BELL BEND NUCLEAR POWER PLANT
RESPONSE TO ENVIRONMENTAL
REQUESTS FOR ADDITIONAL
INFORMATION, FIRST SUBMITTAL
BNP-2009-195 Docket No. 52-039

Responses to Environmental Requests for Additional Information,
Bell Bend Nuclear Power Plant,
Luzerne County Pennsylvania

Figure 2.2-1 Land Use on the BBNPP Site

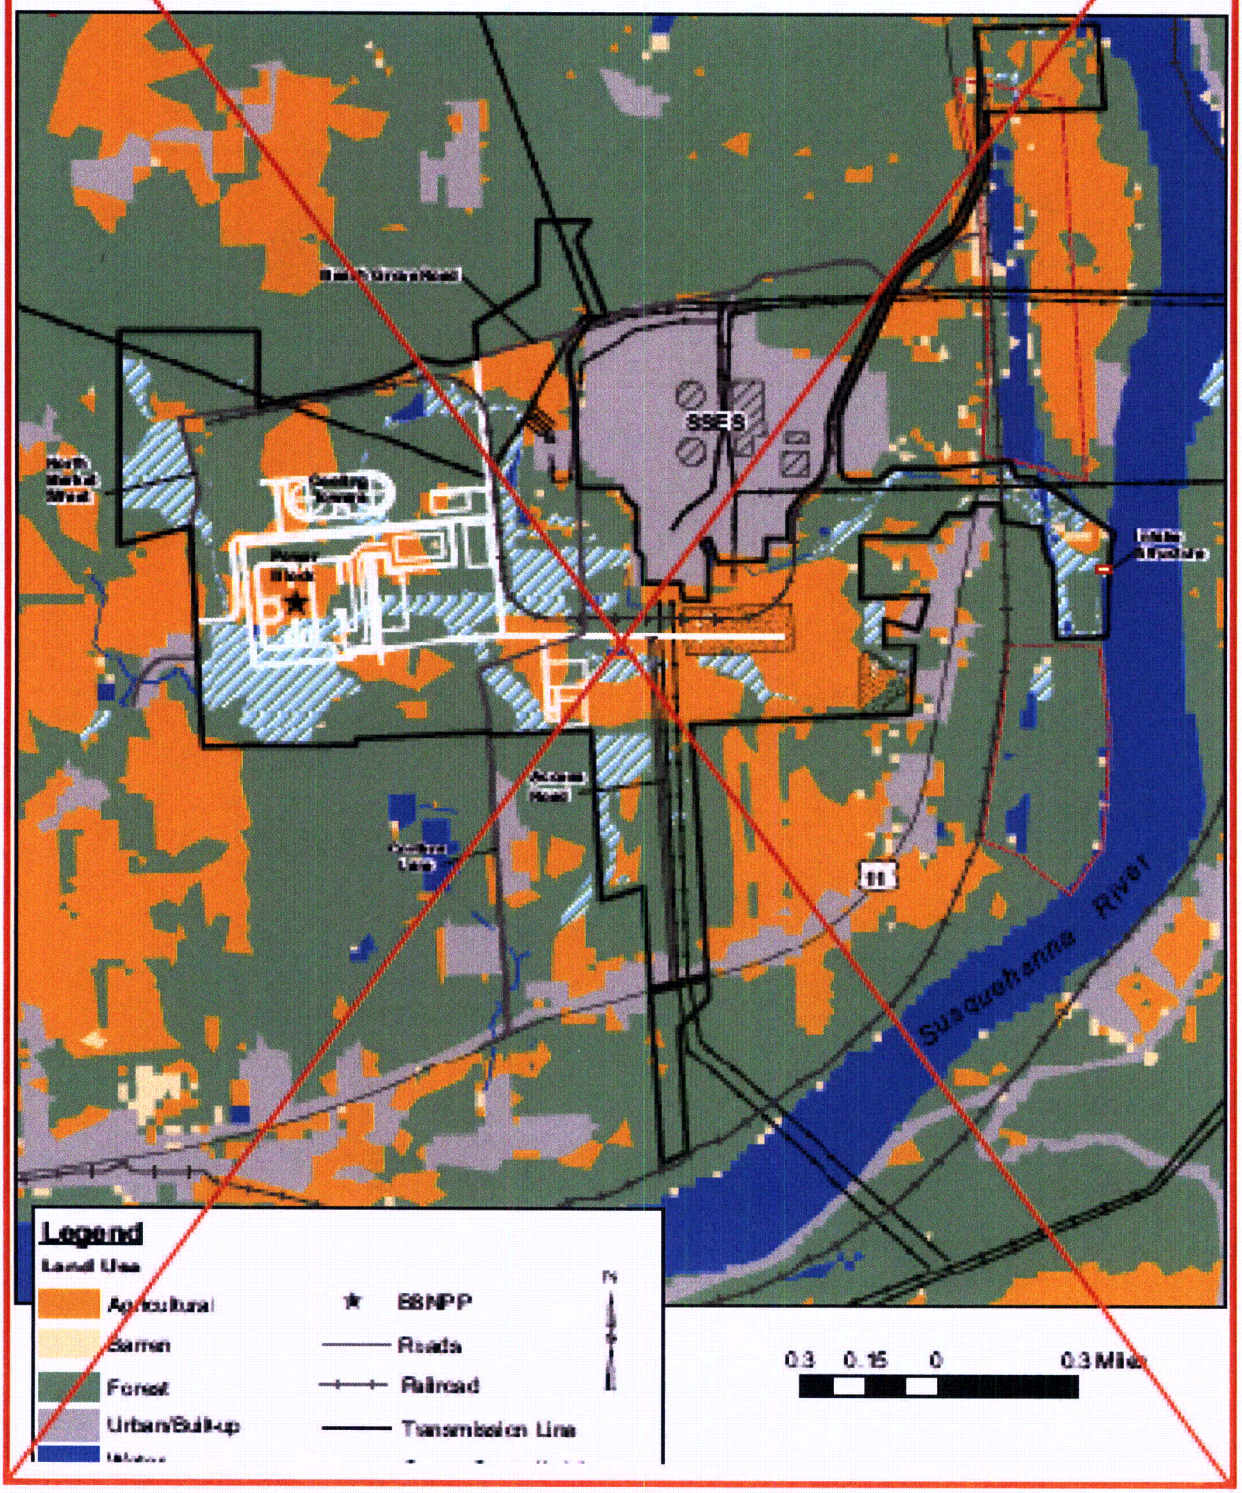
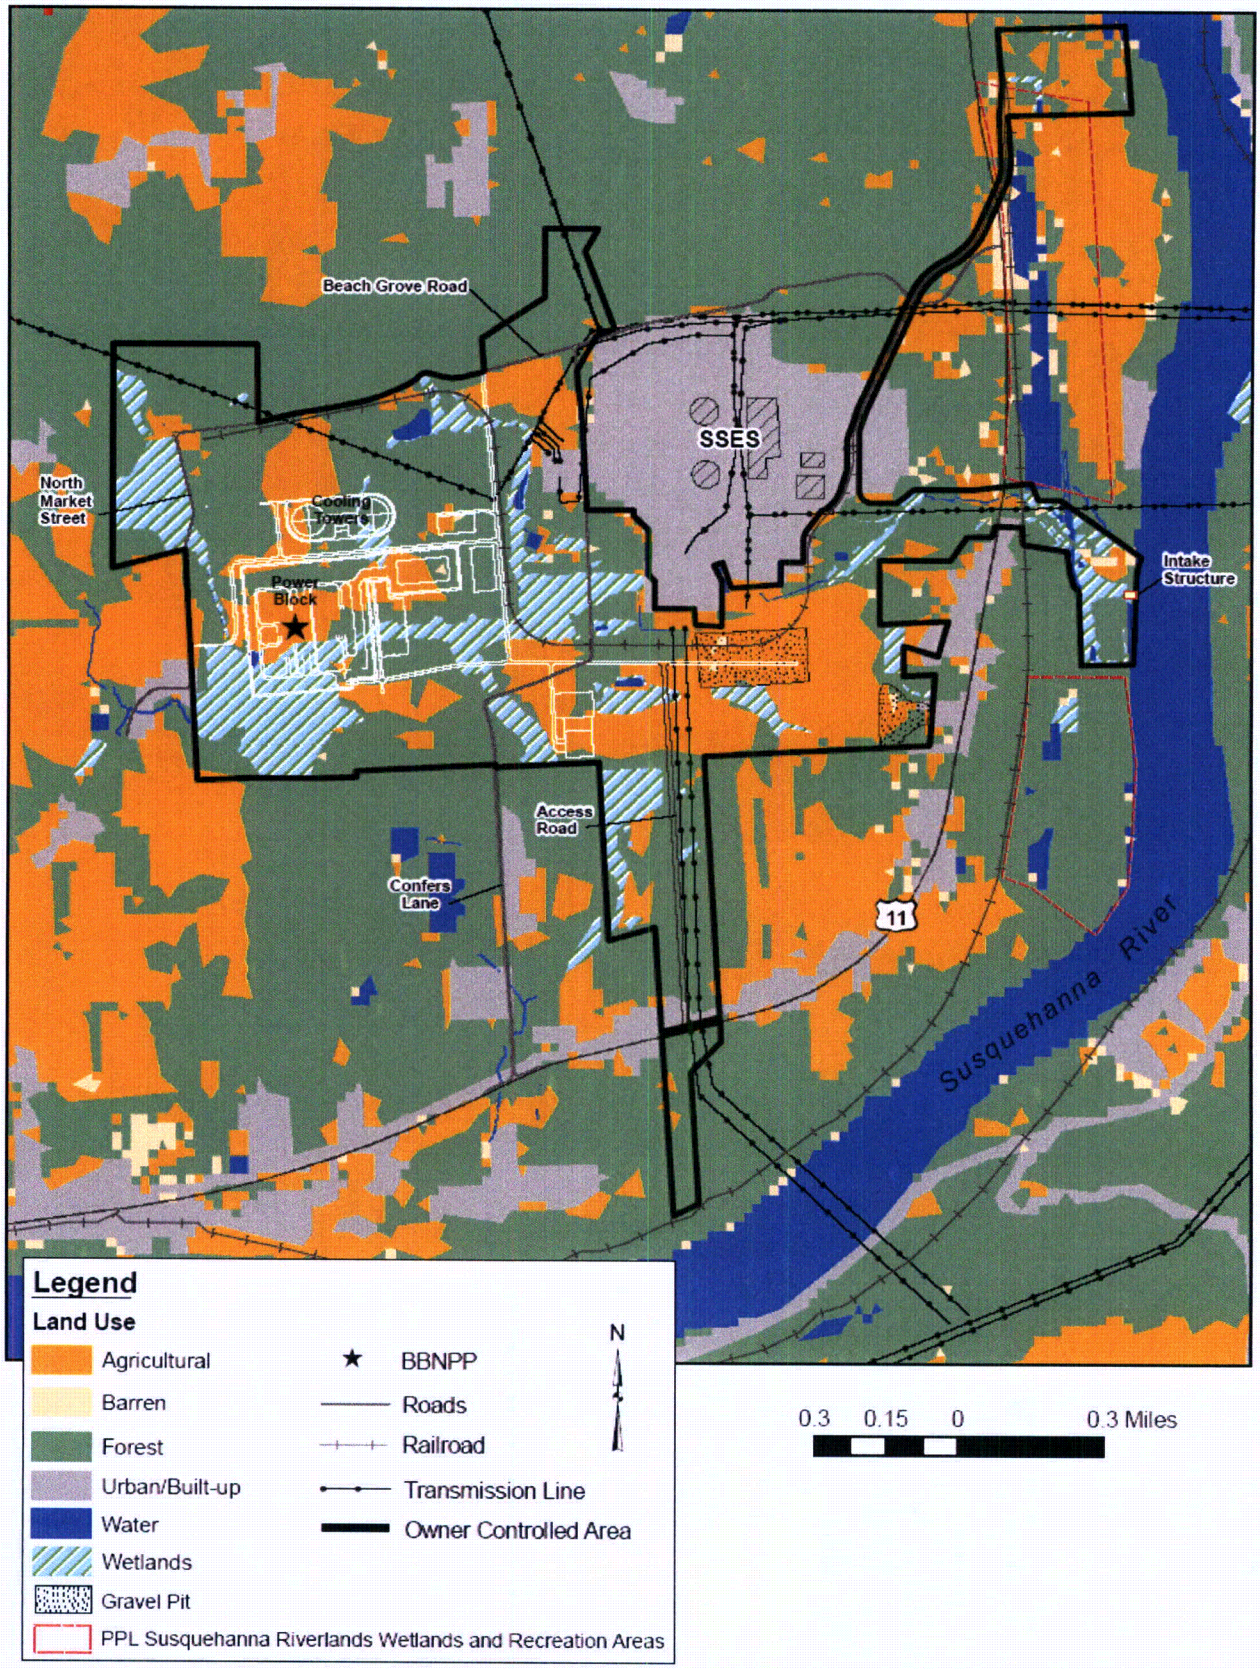
Summary: *Provide Figure 2.2-1 with a clear legend.*

Full Text : Figure 2.2-1, Land Use on the BBNPP Site: The legend is partially obscured, excluding some land use categories.

Response: ER Figure 2.2-1 will be revised to show the entire legend.

COLA Impact:
ER Figure 2.2-1 will be revised to show the entire legend and will be updated as follows in a future COLA revision:
